ROSEVILLE
REQUEST FOR COUNCIL ACTION

DATE: 5/5/2014
ITEM NO: 11.b

Item Description: Request by OP2 Evergreen, LLC, for Approval of a Minor Subdivision of the Property at 1720 Terrace Dr.

Attachments: A: Site plan

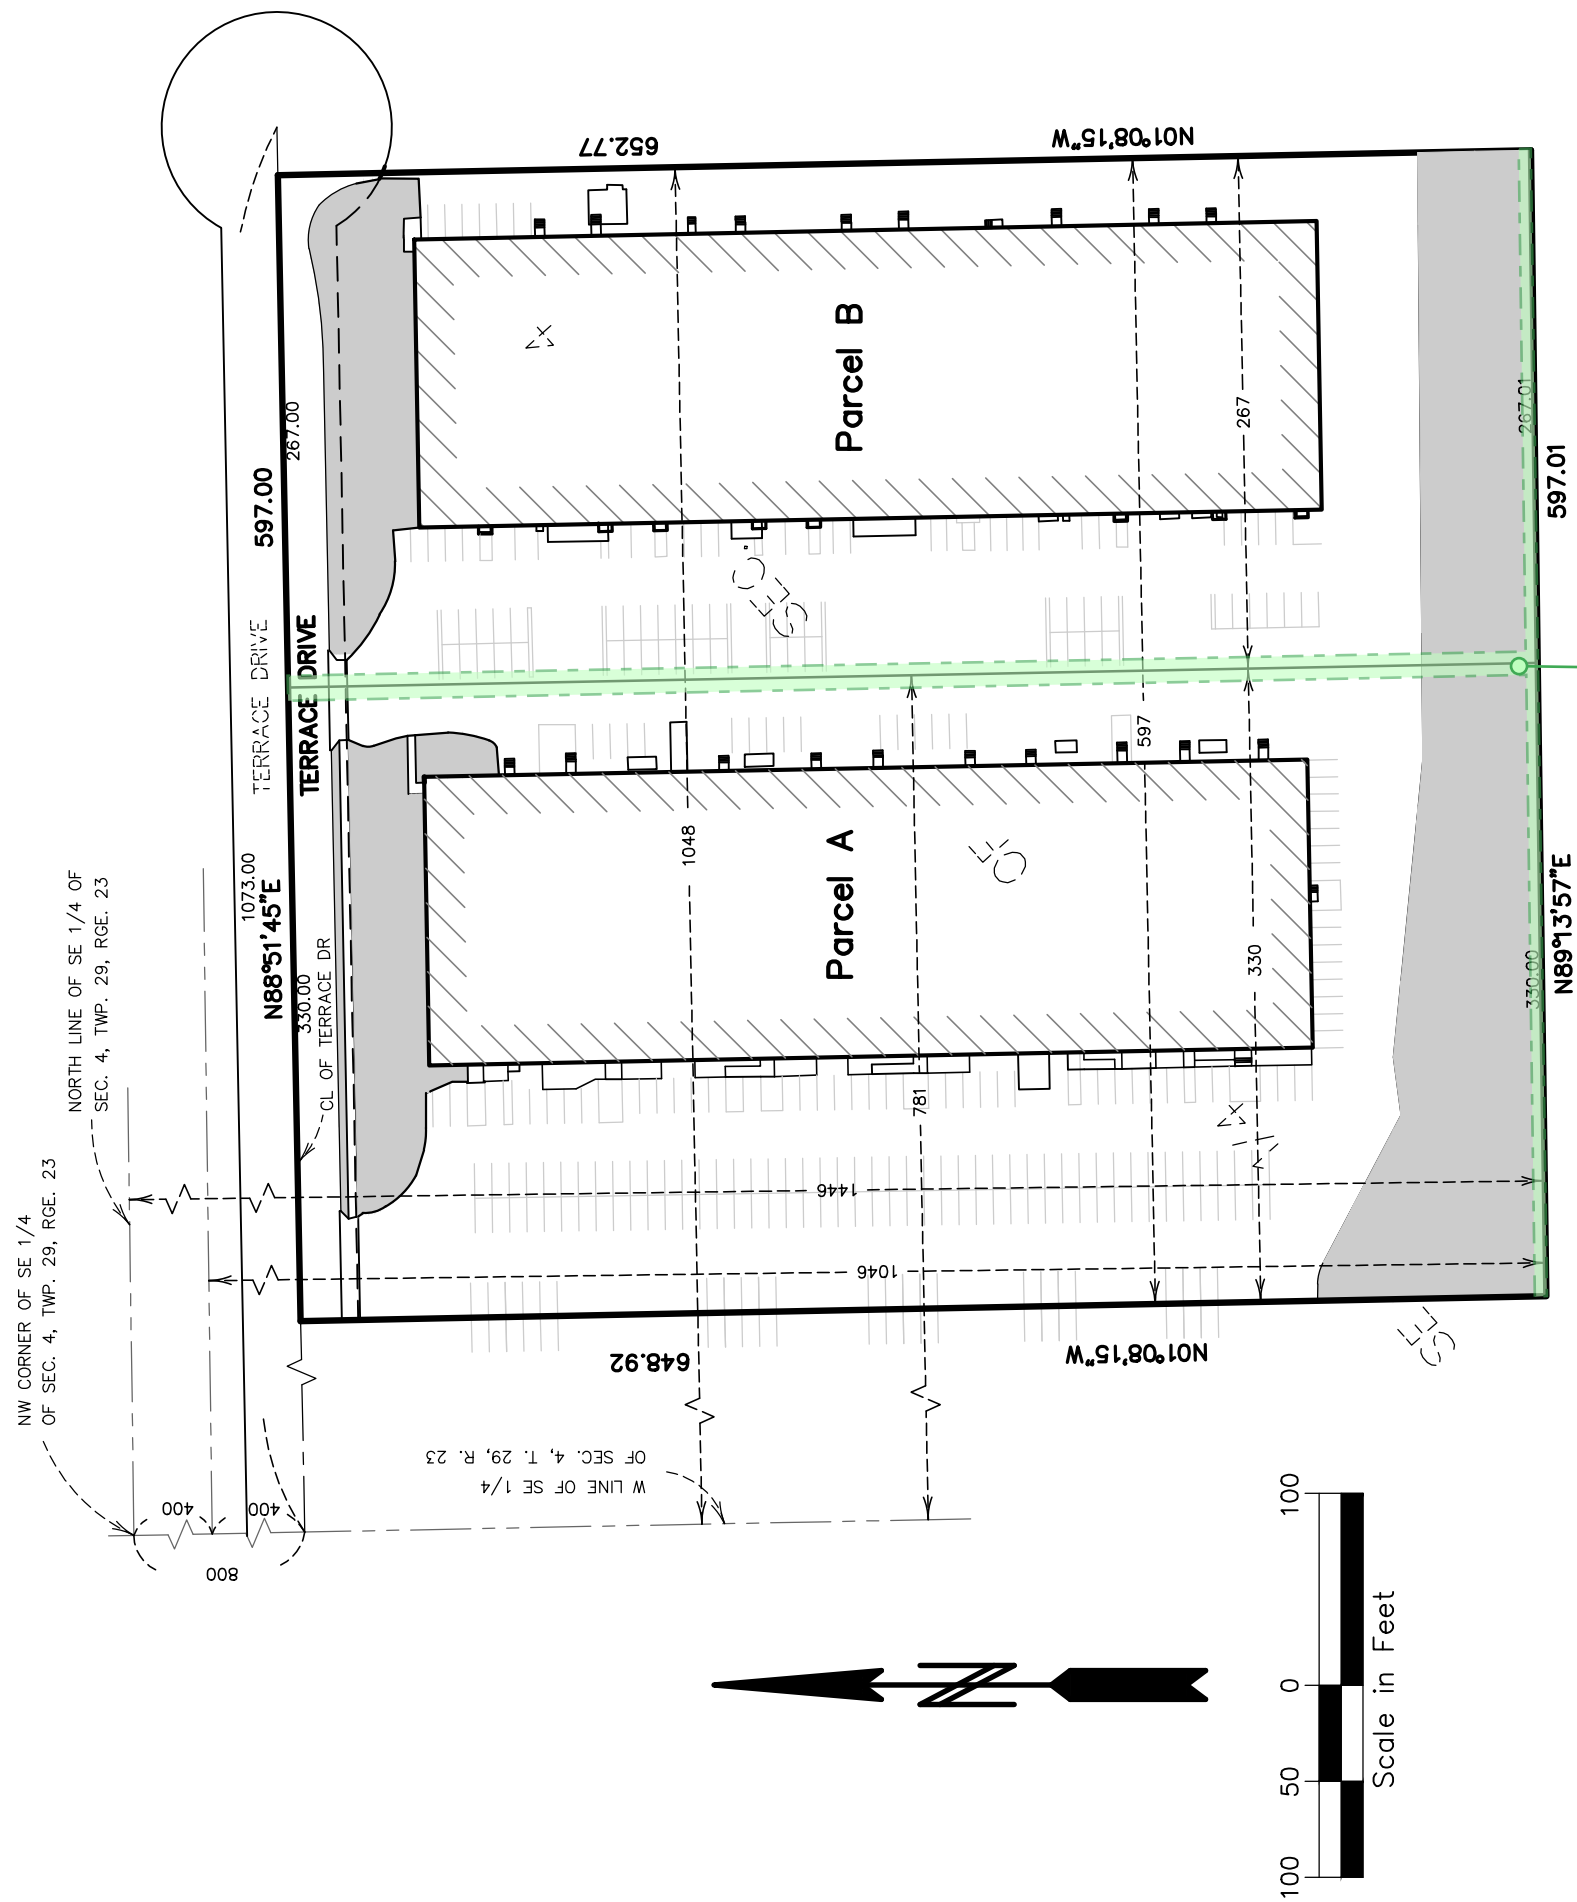
21 5.2 City Code §1103.04 (Easements) requires 12-foot-wide drainage and utility easements
22 centered on the rear and new, common side property lines; these easements are illustrated
23 in Attachment A.

- 34 a. The utility services for each building must not cross the new, shared property
35 boundary;
- 36 b. An easement or other agreement providing shared access of the parking facilities and
37 site entrances will be necessary; and
- 38 c. A building code analysis by an architect will be required to provide allowable area
39 calculations and verify that no increased ratings would be required due to the
40 proposed location of the property line.

41 5.5 Depending on the results of the architect’s analysis of the existing buildings, the
42 proposed common parcel boundary may shift from its proposed location. The final
43 location of the new parcel boundary will need to be such that both new parcels meet all
44 applicable requirements of the Zoning Code.

- 55 a. Drainage and utility easements shall be dedicated as illustrated on the site plan
56 reviewed with this application;
- 57 b. The utility services for each building shall not cross the new, shared property
58 boundary;

- 59 c. An easement or other agreement providing shared access of the parking facilities and
60 site entrances shall be submitted for administrative review and approval prior to
61 recording the subdivision documents at Ramsey County;

- 62 d. A building code analysis by an architect providing allowable area calculations and
63 verifying that no increased ratings would be required due to the proposed location of
64 the property line shall be submitted for administrative review and approval prior to
65 recording the subdivision documents at Ramsey County; and
